Subject: F53 Cassette Locking Tabs Bending

Fujitsu Frontech NA	PRODUCT SUPPORT BULLETIN	PSB-09-008
	Sustaining Engineering		OHIR418
	San Diego, CA; Montreal, QC		April 24, 2009

Bottom of Cassette

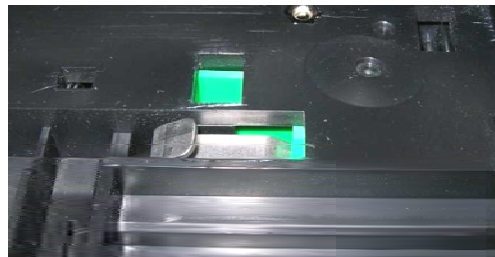
Reliability improvements have been implemented to the F53 BDU Cassette to prevent its Locking Tab from getting bent.

Bent Tab

OK Tab

Problem

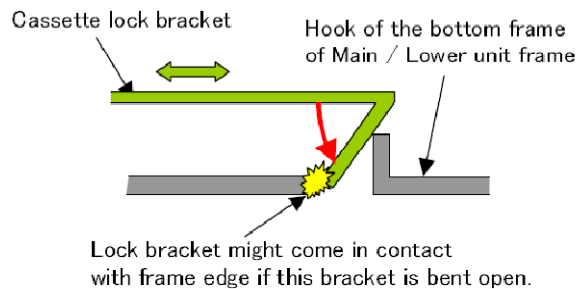
If the tab gets bent slightly, it will then catch on the metal base of the F53 Main Unit which bends the tab even further. This makes the cassette difficult to insert, can make it difficult to release and remove, and can also cause the Cassette to make a grinding noise when operated.

Replace Metal Locking Tab with stronger version.

- KD02881-E531 Cassette Locking Metal Tab (rev 10).
- This change was cut into Cassette production: Rev 10F or above, cassette serial #KA00045793.
- The Locking Tab part number did not change, all future orders of this part will be the new revision.
- The only visible difference is the new Tab is Thicker/Heavier metal (1.5mm instead of previous 1mm thick).

Mylar Film

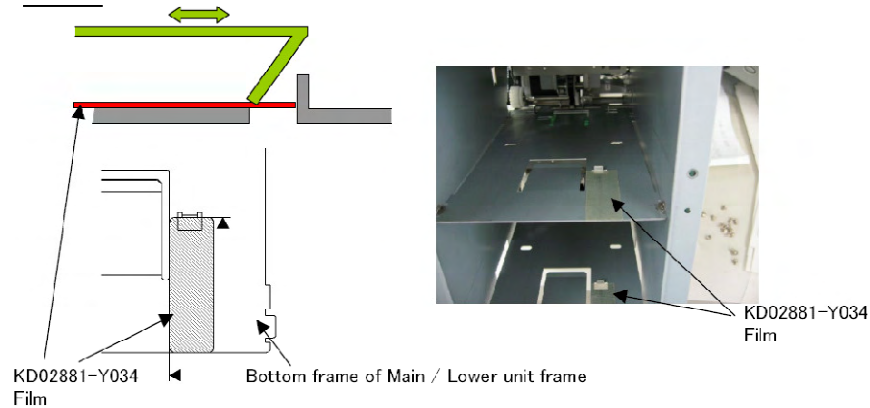
Install Mylar film to protect cut out in F53 Main Unit.

- KD02881-Y034 Mylar Film
- This change was cut into F53 production: Rev 02B or above.
- See illustrations under Installation Instructions below.

1. Remove the Cassette from the F53 unit.
2. Remove the Mylar Film (KD02881-Y034) from its protective backing.
3. Position the Mylar Film on the base of the Main Unit positioned against the Frame Locking Tab and square with the metal frame. See illustration above.
4. Firmly press the Mylar Film onto the metal frame to make sure complete adherence.
5. Re-install Cassette.
6. Repeat for all Cassettes in F53 BDU.
